SEAT

■ FRONT SEAT

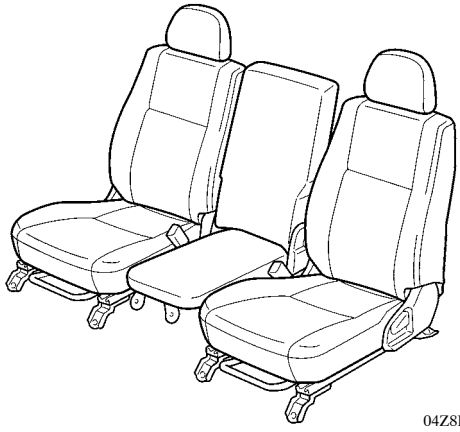
- The front seat of the Hong Kong package models has been changed from the 3-passenger bench type (1 + 2) to a separated type (1 + 1 + 1).
- The head rests for the Hong Kong package models have been changed from the integrated type to a separated type.
- A seat slide function (120 mm) has been provided to the passenger's seat of the Hong Kong package models. Along with this, the manufacturer's optional provision of the passenger's seat slide function (225 mm) has been abolished.
- The passenger's seat of the Hong Kong package models has been changed from the full-reclining structure to a semi-reclining structure.
